## **I. Proposal**

**"5.6.4. Special Provisions for ACSF of Category C**

Fig. 1  
Figure Minimum detection area

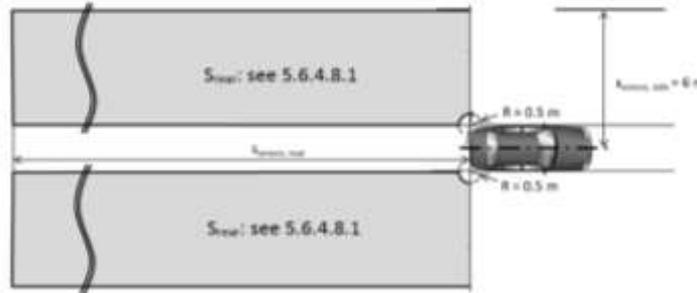
5.6.4.8.2. The vehicle system detection area on ground level shall be at minimum as shown in

the figure below.
